Lamb Pines - Update #1

CITY OF LAS VEGAS		DATE:
INTER-OFFICE MEMORANDUM		September 23, 2015
TO: Land Development Services Department of Building & Safety		FROM: Albert Sung, P.E. Flood Control Project Engineer Department of Public Works
SUBJECT:	Drainage Study for:	
	Lamb Pines – Update #1	
Cross Streets:	SWQ of Lamb Boulevard & Bonanza Road	
File Number:	F:\Depot\DSMemos\DS4740C.doc	
Parcel Number:	140-31-501-021	
Zoning Action:	SDR-58124; VAR-58121 to VAR-58123; GPA-57254 & ZON-57255	
FEMA Flood Zone	YES	NO X
Proposed Storm Drain	YES	NO X
COPIES TO:		L. R. Nelson Consulting Engineers Nevada H.A.N.D. Bart Anderson, P.E., DevCo CCRFCD

UPDATE NO. 1 TO THE TECHNICAL DRAINAGE STUDY FOR LAMB PINES

Subject: Update No. 1 to the TDS for Lamb Pines - DS4740UP

Regional Flood Control District
600 S Grand Central PKWY Suite 300

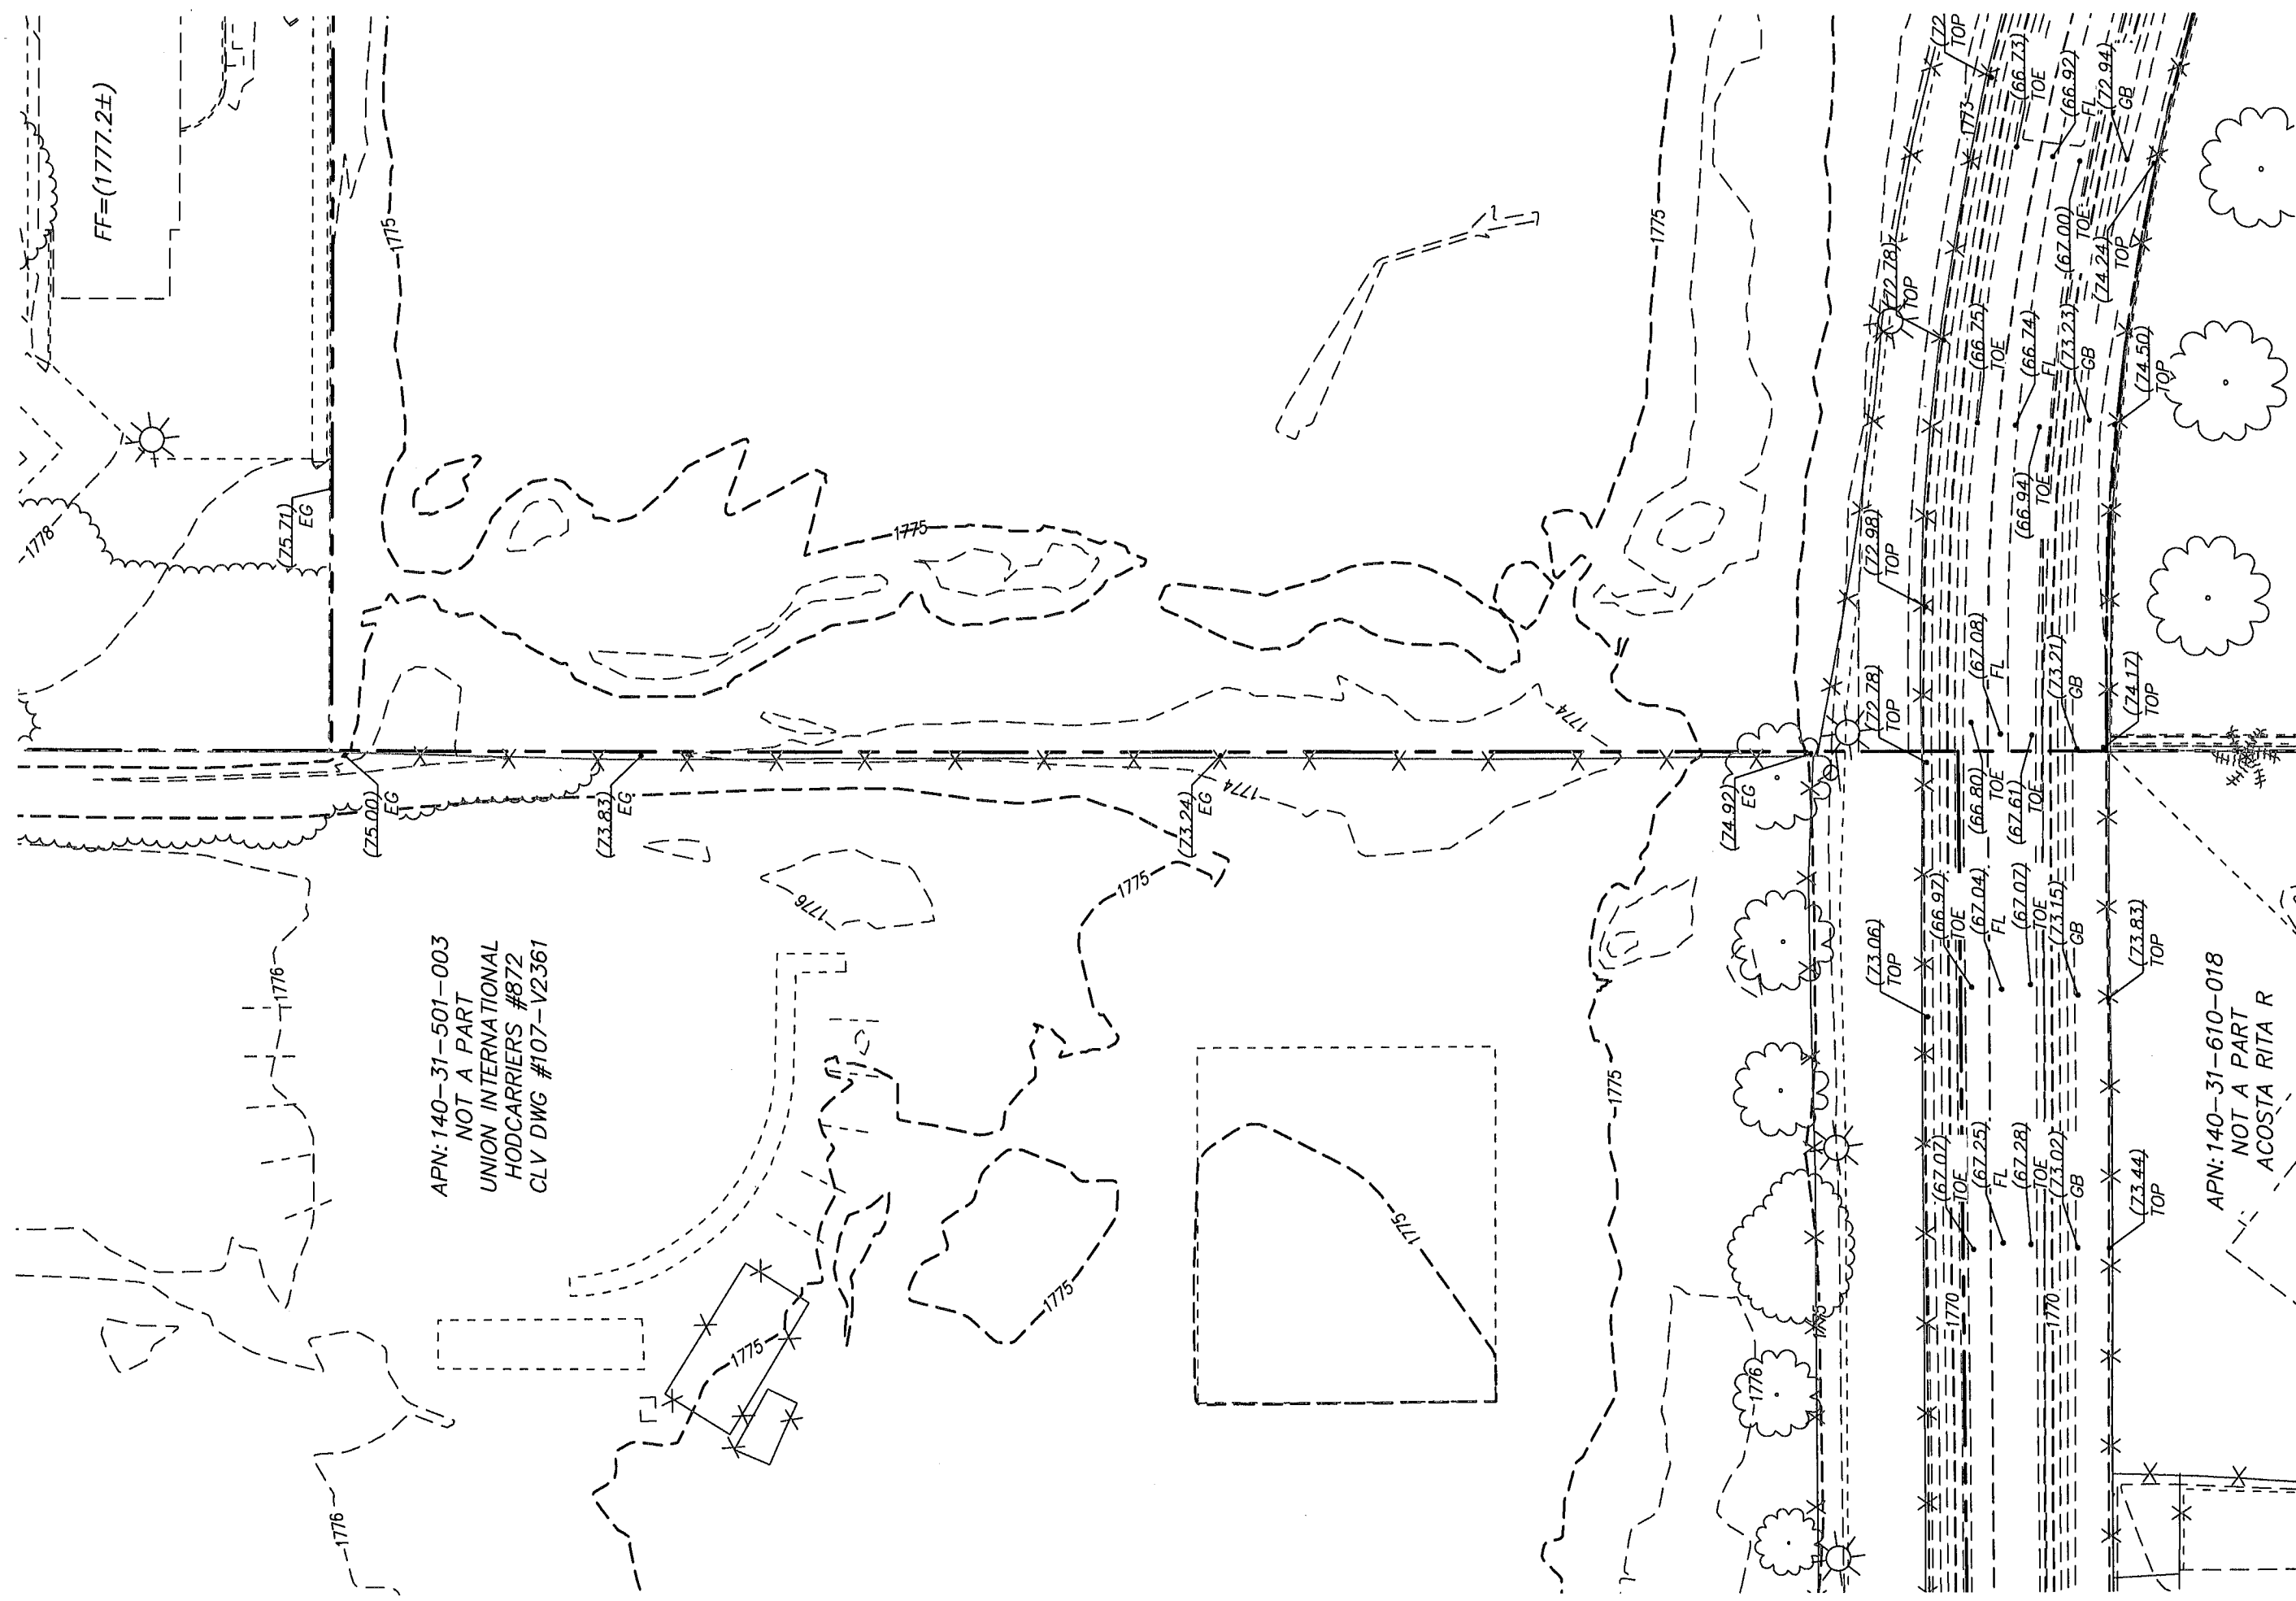
Verify the WSE elevations. They are in the 1900. Revise and e-mail me new sheets.

Notes: Show the Q and HGL on the storm drain profile. Consider grated manhole covers if HGL does not meet 1' below finished grade requirement. Send updated sheet(s).

Attached with this email are the three grading sheets with the revised elevation for the HEC-RAS Sections. Let me know if you need anything else.

There is no need to put a HGL or flow on the profiles because the system is designed to be overtopped during the 100 year event. The HGL for the system is based off of the HGL established as part of the HEC-RAS modeling. All flood waters regardless of storm event will go into the channel. Either by the storm drain or by the emergency overflow provided at each storm grate. Due to the flood levels provide for in the HEC-RAS modeling and the flat slope of the site it is impossible to design a storm drain system that meets HGL requirements. The City of Las Vegas approved this scenario and it is addressed in the report narratives.
